**GOVERNMENT OF THE DISTRICT OF COLUMBIA
DEPARTMENT OF TRANSPORTATION**

MEMORANDUM

SUBJECT: ZC Case No. 07-13G – 65 I Street SW (Randall School)

Figure 2 – Currently Proposed (2017) PUD Site Plan (Source: Transportation Memo, Grove/Slade, Figure 7, 2/26/18)

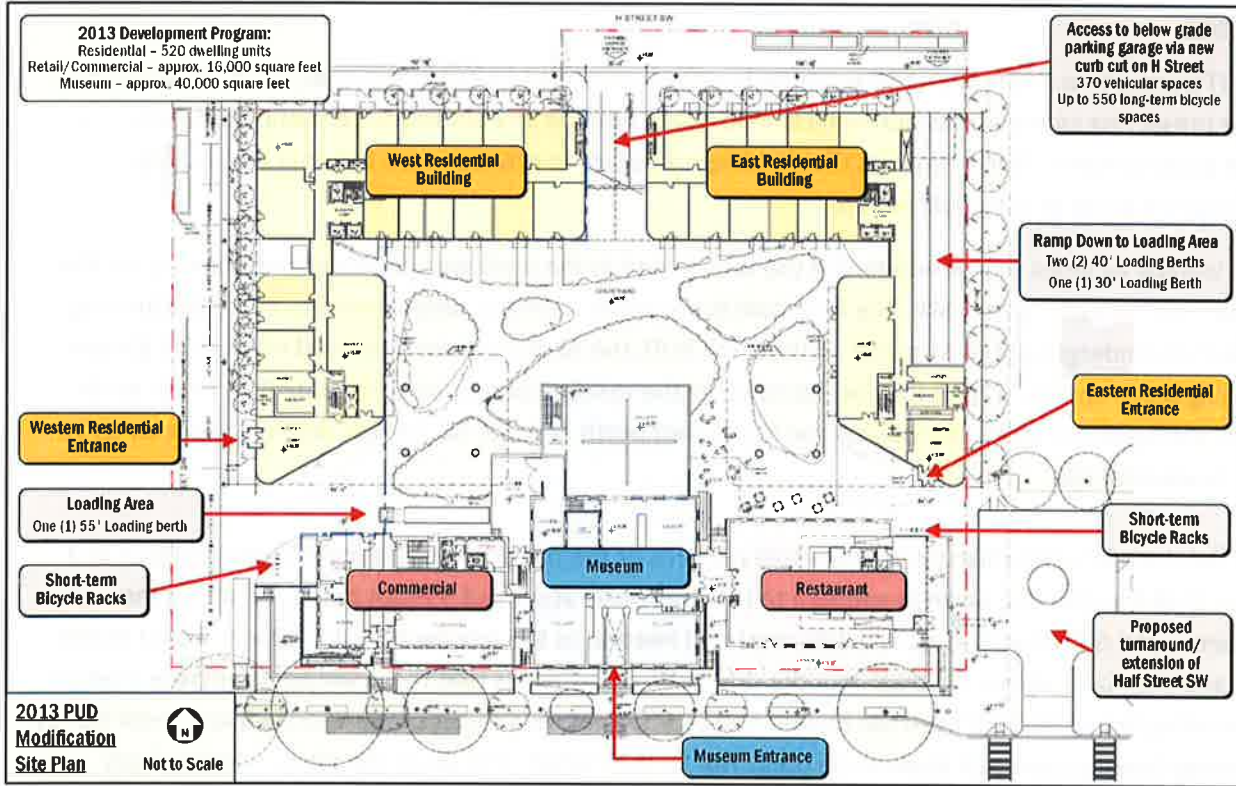
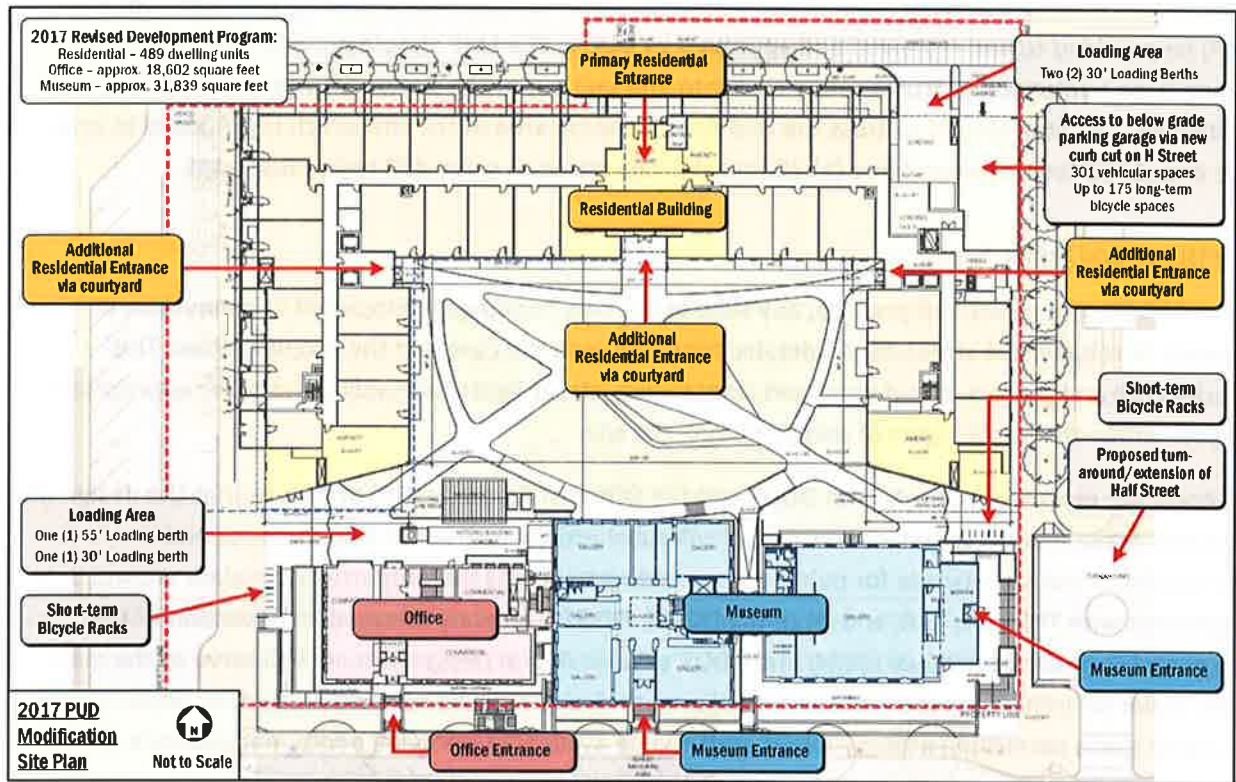
Primary vehicular access to the underground parking garage was previously proposed on H Street SW in the middle of the site. It is now being proposed further to the east, still on private property. This driveway would be immediately adjacent to the driveway leading to the residential loading area, which is proposed in the same location as the previous approval but at-grade rather than underground. The vehicle turnaround proposed from I Street SW, just east of the site opposite Half Street SW, is not proposed to change location. DDOT understands the Applicant has an agreement in place with the Department of Parks and Recreation to construct and use the turnaround. The driveway for large trucks seeking to access the historic building will continue to be provided via the one-way northbound private half of 1st Street SW. The one way southbound public half of 1st Street SW will be separated from the private portion by a concrete median and will serve the Ward 6 Short Term Family Housing development (BZA 19451).

Pedestrian access for the museum and office portions of the development will be via entrances on I Street SW and the turnaround east of the site opposite Half Street SW. Residents of the property may either access the buildings via entrances on H Street or 1st Street SW. Figures 1 and 2 below show the previously approved and currently approved site layouts of the Randall School redevelopment.

DDOT finds the new driveway location and access scheme, all proposed on private property, in the revised site plan to be acceptable. Additionally, the Applicant should provide a public access easement for the private portion of 1st Street SW to ensure access and transportation network connectivity.
